# PROPOSED FIRST FLOOR PLAN

BAND ON THE WALL
PROPOSED FIRST FLOOR PLAN
1387 | L 1003 REV.E JULY '20 | 1:100 @ A3

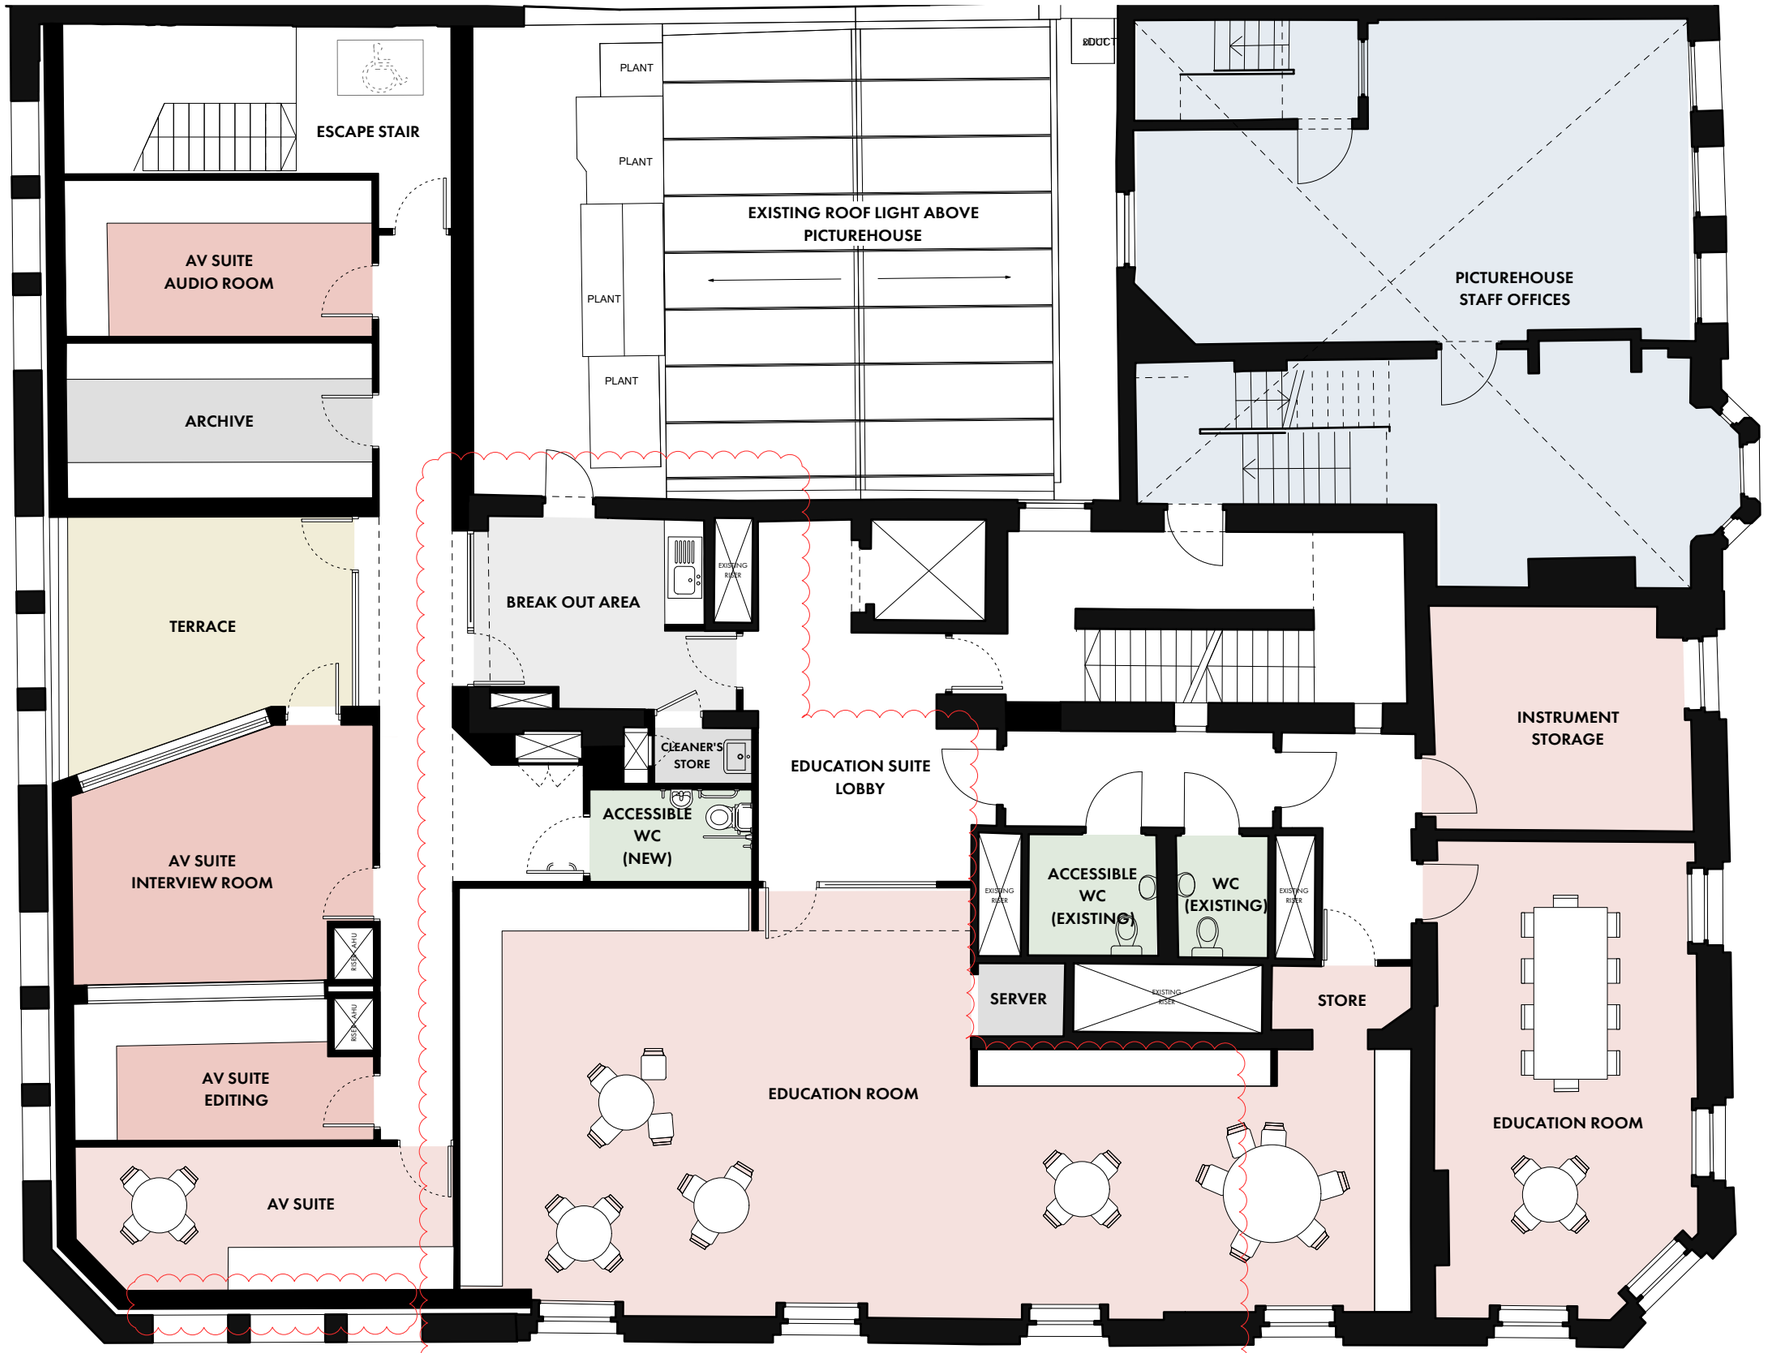
REVISION NOTE:
ALL WINDOWS OMITTED TO UPPER FLOOR (NOT INCLUDING TERRACE) DUE TO CLASH WITH EXISTING FACADE AND NOT REQUIRED FOR ROOM USAGE

REVISION NOTE:
INTERNAL RECONFIGURATION TO MAXIMISE EDUCATION SUITE & MINIMISE WORKS TO EXISTING STRUCTURE & SERVICES. CIRCULATION SPACE RATIONALISED
